COMMENTS ON THE DRAFT BASIC ASSESSMENT REPORT FOR THE KLEINFONTEIN SOLAR PHOTOVOLTAIC 1 (PV) ON PORTION 1 OF THE FARM KLEINFONTEIN NO 369, VILJOENSKROON, FREE STATE PROVINCE

The draft Basic Assessment Report (BAR) dated March 2023 and received by this Competent Authority (CA) on 03 April 2023, refers.

Kleinfontein Solar PV1 (2023-02-03)

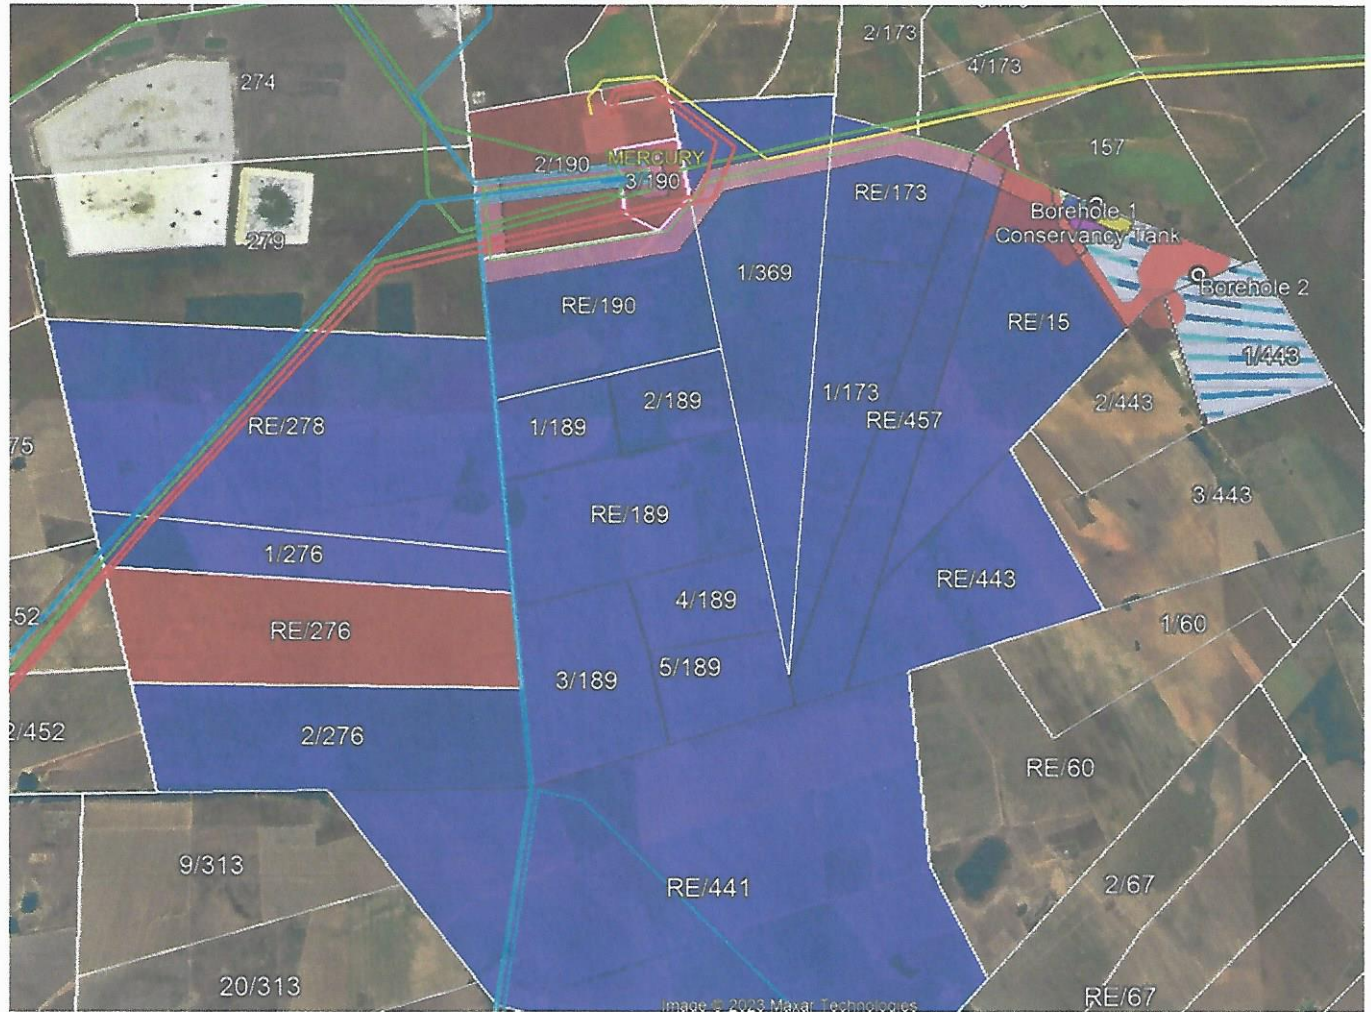
Attached are the depictions of how the 2X 765kv power lines will be affected by each of the 5 plants/facilities. Please note that the servitude width for both lines will be between 200m to 220m wide and mostly running parallel to the existing powerlines.

Red lines indicate the 2 x Mercury – Umtu 765kV Lines

Figure 3: Connection strategy for Mulilo solar PV projects.

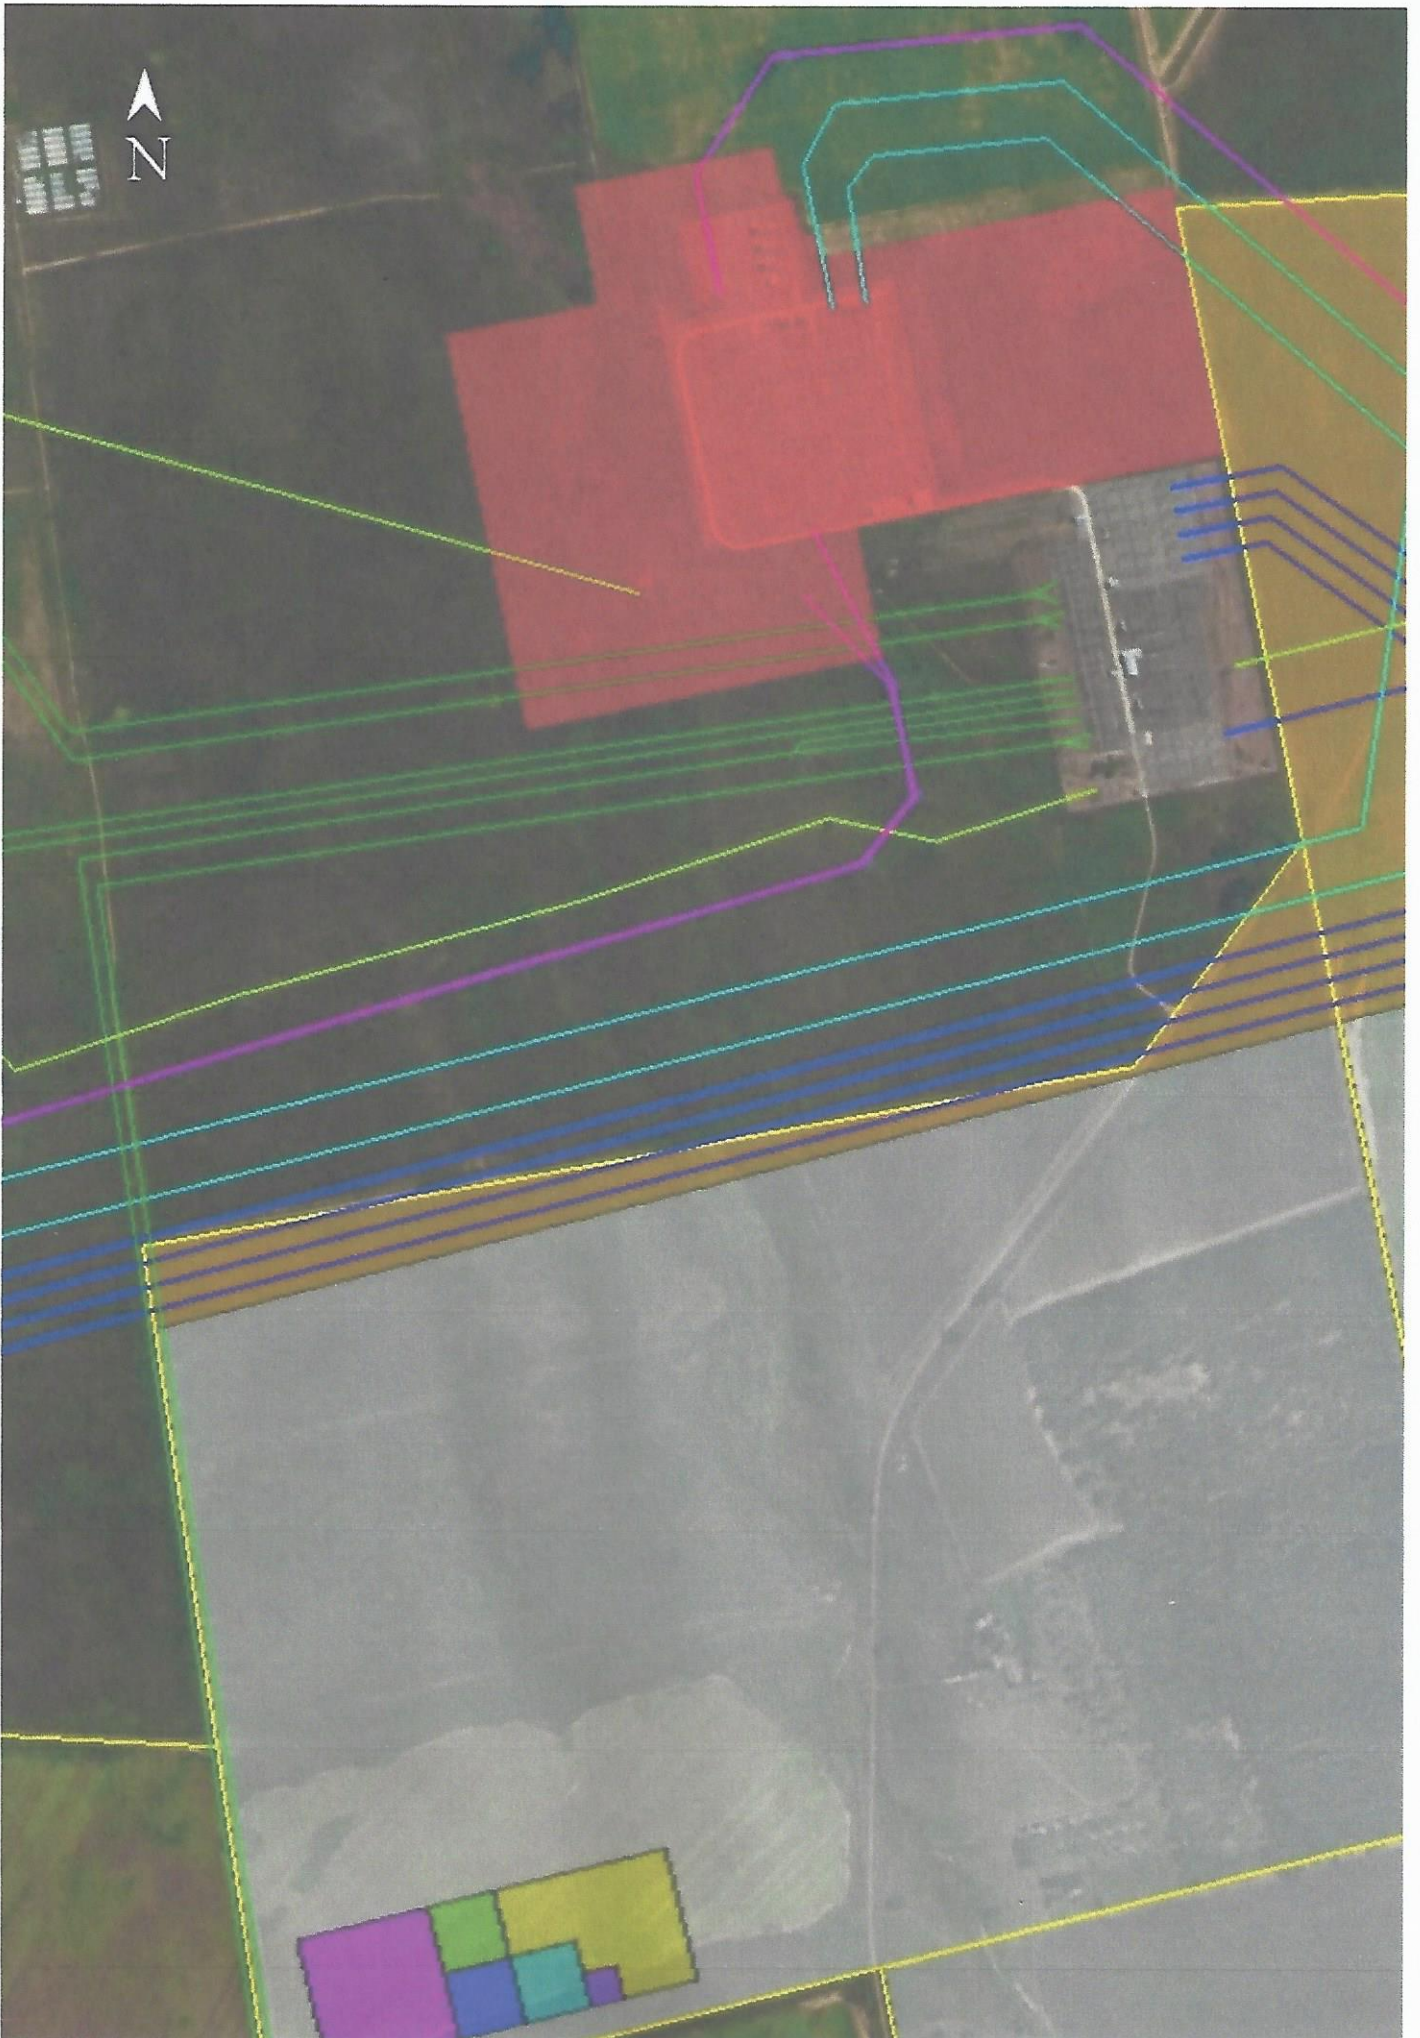
The development footprints of Kleinfontein Solar PV1 and Zaaiplaats Solar PV1 were however, understood to represent an issue for Eskom where there was concern raised over the possible interference with planned 765KV infrastructure as well as constraining the possible future access and future expansion of the Mercury MTS.

As a result of these concerns, Mulilo has agreed to work with Eskom in finding a balanced compromise which is mutually beneficial to both parties. To address Eskom's comments, Mulilo has redesigned the Project Sites to take into account the specific concerns raised by Eskom. This has been accomplished by firstly removing solar plant infrastructure in the planned 765kv corridor, secondly, through limiting construction on the Eastern side of the Mercury MTS to allow possible expansion and potential new powerline servitudes and finally, by incorporating two additional 400kv powerline servitude corridors as no go buffers along the entire southern and eastern sides of the MTS to ensure access to the MTS and potential expansion remain available to Eskom. Please find these amendments illustrated by the areas shaded in orange in Figure 1 below where Kleinfontein Solar PV1 has been reduced by 122 ha and Zaaiplaats Solar PV1 by 14 ha. The location of the laydown areas, BESS area, O&M buildings, diesel storage areas, IPP substations and Eskom switching stations were also adjusted following Eskom's comments to allow for future IPP projects to connect to these projects' satellite/collector switching stations thus growing the Eskom network away from the Mercury MTS and ensuring future IPPs can connect without further adding to the servitude congestion around the Mercury MTS.

Figure 3 illustrates a possible connection strategy for reducing the number of 132 kV lines running from Mulilo's PV projects directly to the Mercury substation. In this configuration, Zaaiplaats Solar PV1 will act as the collector substation. Ratpan Solar PV1 can connect to the 132 kV busbar at the Hormah Solar PV1 switching station. From there, a 132 kV twin tern line can connect both Hormah Solar PV1 and Ratpan Solar PV1 to the 132 kV busbar at the Zaaiplaats Solar PV1 switching station. Similarly, a 132 kV twin tern line can connect the Vlakfontein Solar PV1 project to the busbar at the Kleinfontein Solar PV1 project (alternatively loop-in-loop-out of the 132 kV line connecting Kleinfontein Solar PV1 to Zaaiplaats Solar PV1). A **double circuit twin tern** 132 kV line can be constructed from the Zaaiplaats Solar PV1 switching station to the Mercury Substation to ensure adequate capacity for all the projects connecting to the collector station.

Figure 4: Potential expansion area next to Zaaiploaats Solar PV1 switching station.

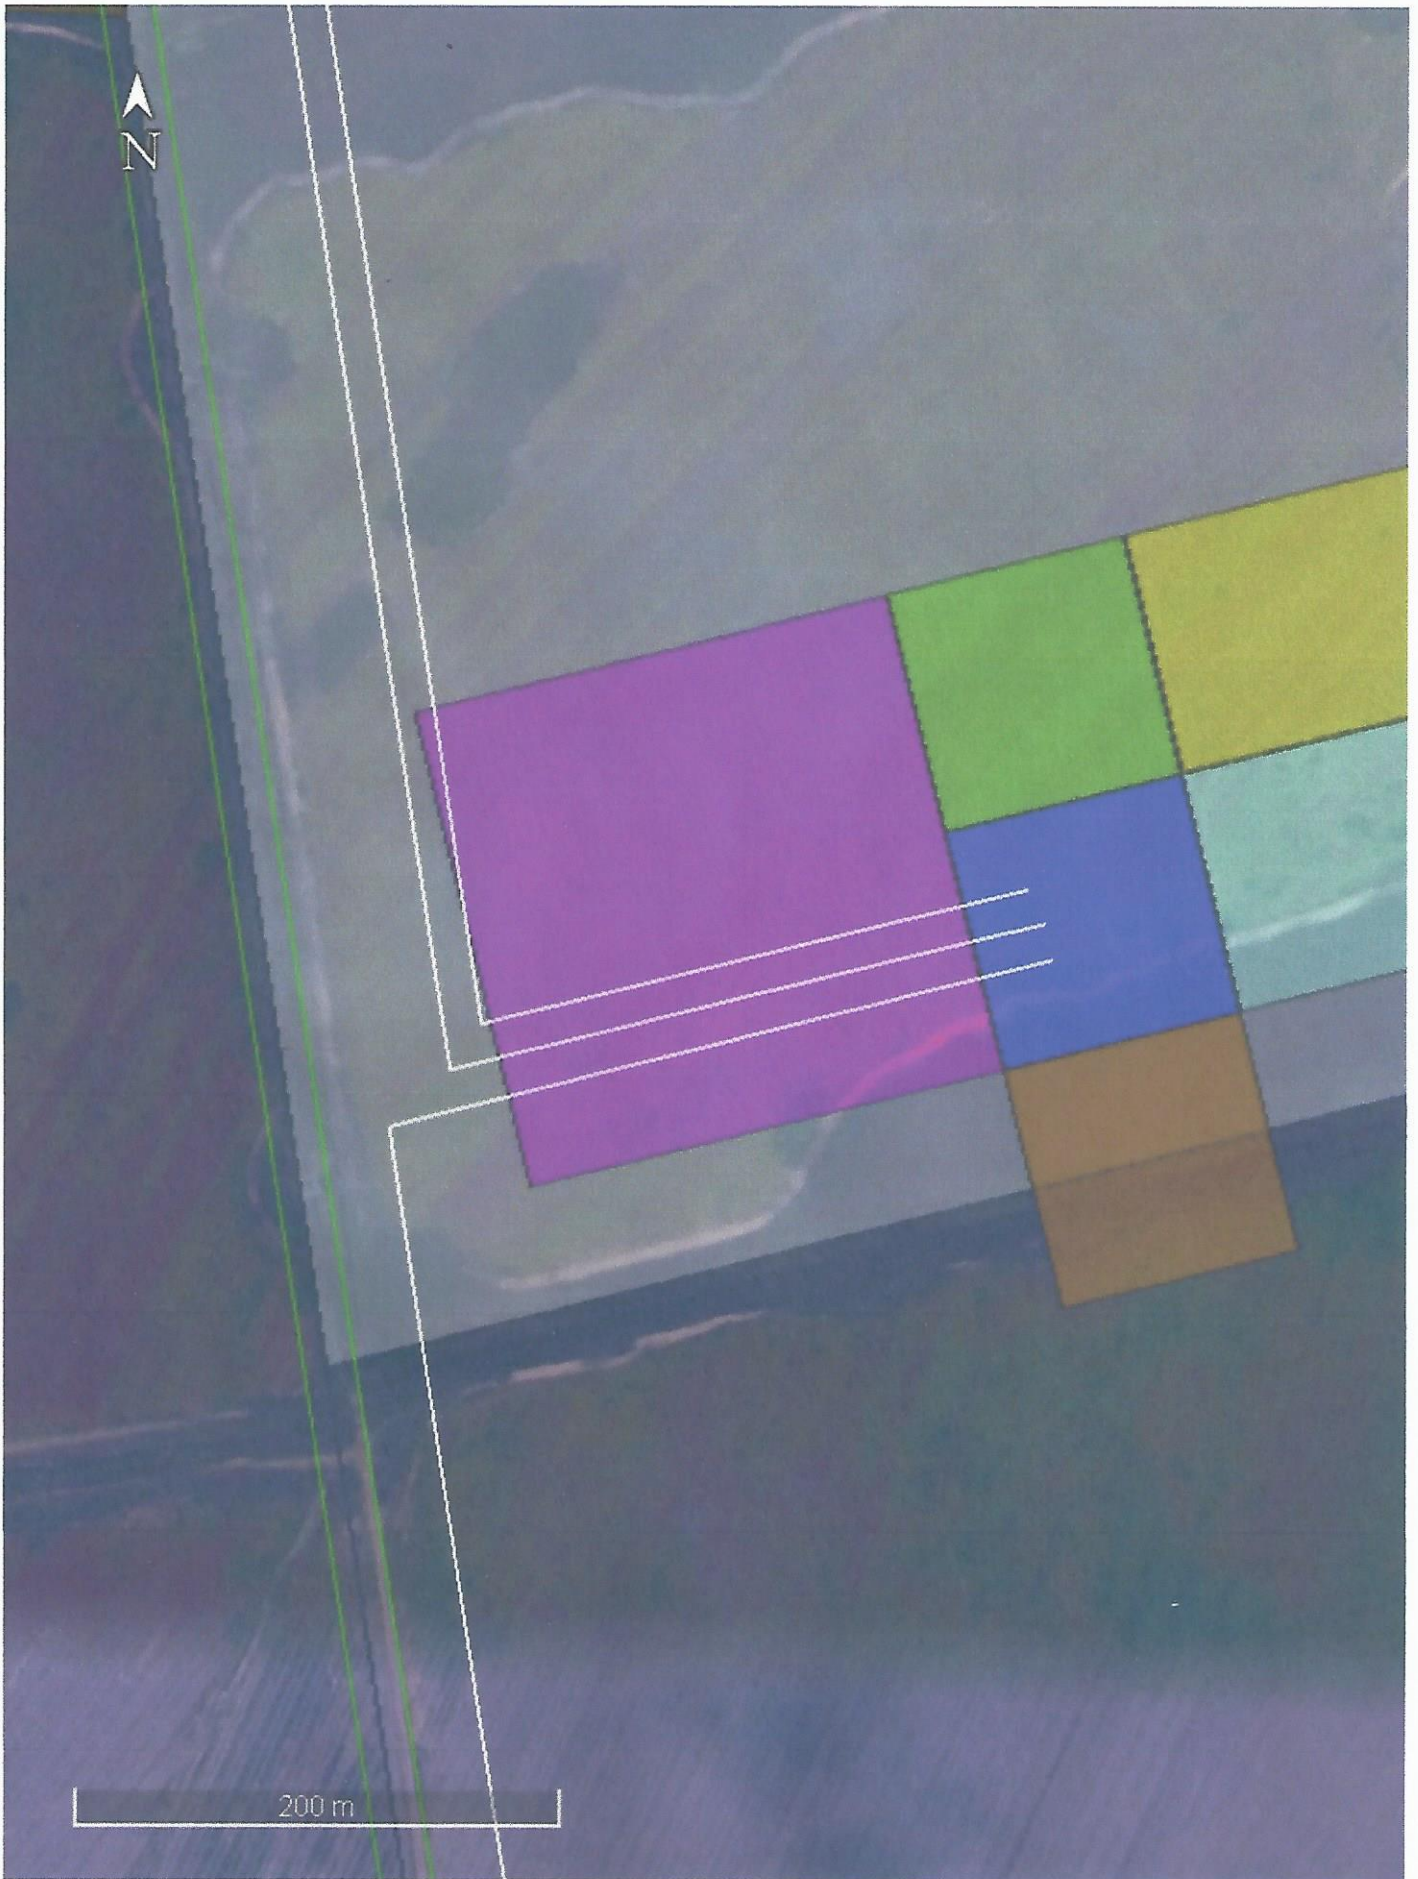
The new location of the Zaaiplaats Solar PV1 substation and switching station also allows for expansion onto neighbouring properties, without negatively impacting the project footprint. This will allow surrounding developers to also connect to this collector station if required, thus addressing Eskom's concerns regarding sterilizing access to the Mercury substation. Please see Figure 4 below where the potential expansion area is shown in brown. A similar approach can easily be followed for expanding the Vlakfontein Solar PV1, Hormah Solar PV1 and Kleinfontein Solar PV1 switching stations.
